MARK	DATE	DESCRIPTIONS	BY	CH'D	CCO#
1	07/21/06	W2 CAP BEAM ISD	JD	NV	23

CONTRACT CHANGE ORDER NO. ____
SHEET ___ OF ___

SAN FRANCISCO OAKLAND BAY BRIDGE
EAST SPAN SEISMIC SAFETY PROJECT
SELF-ANCHORED SUSPENSION BRIDGE (SUPERSTRUCTURE & TOWER)

W2 CAP BEAM POST-TENSIONING DETAILS NO.10

SECTION D-D
1:20 (see Note 9)

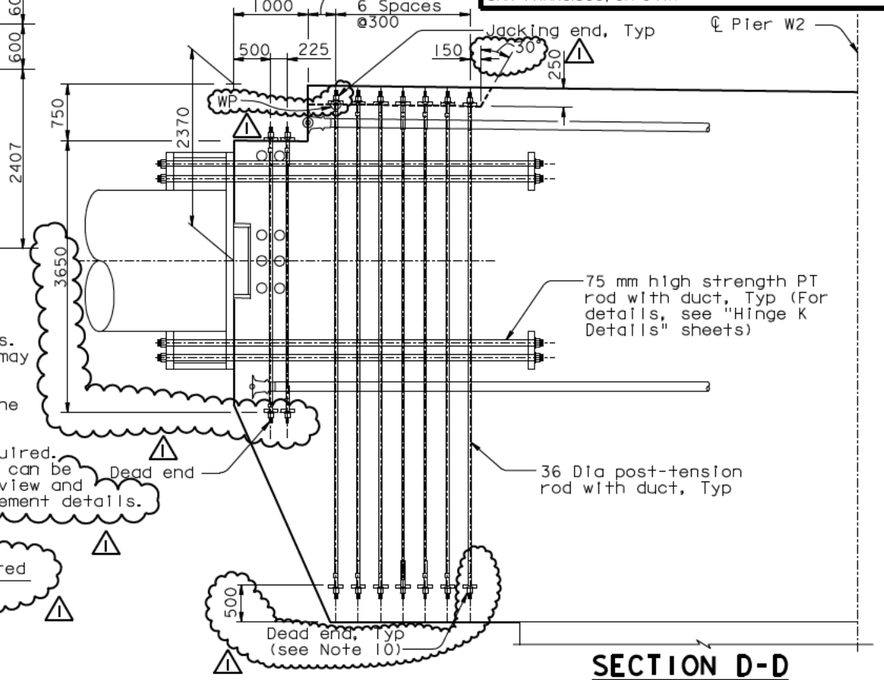
9. Contractor shall sequence stressing between cap beam continuity tendons and post-tensioning rods to avoid interference with stressing operations. At the Contractor's option, trumpets may be angled to improve access. Trumpet layout and corresponding additional reinforcement shall be submitted to the Engineer for review and approval.

PLAN-VERTICAL STRAND TENDON AND POST-TENSION ROD ARRANGEMENT
DETAIL B
1:40

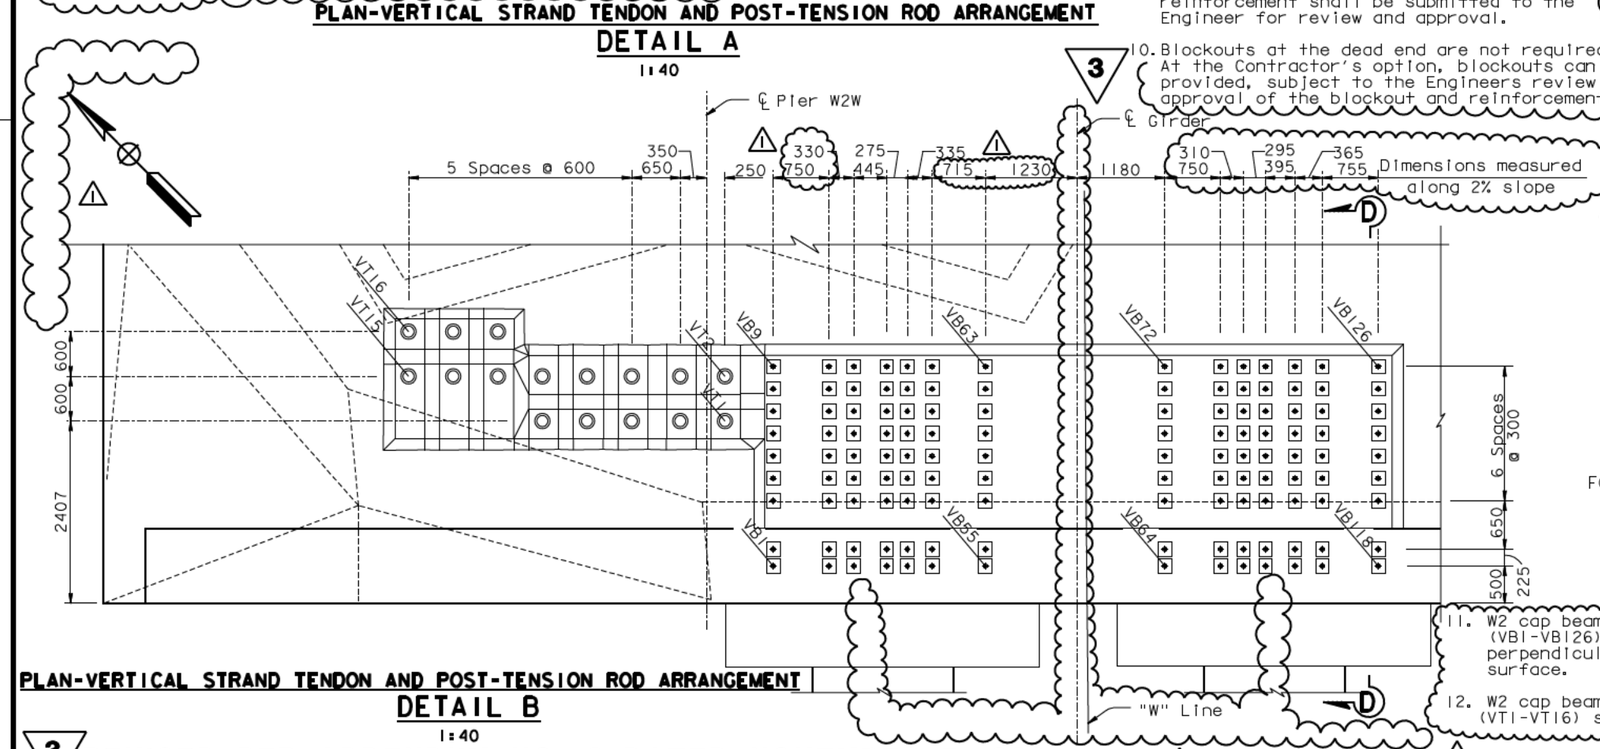
11. W2 cap beam vertical PT rods (VB1-VB126) shall be placed perpendicular to the top concrete surface.

12. W2 cap beam vertical tendons (VT1-VT16) shall be placed vertical.
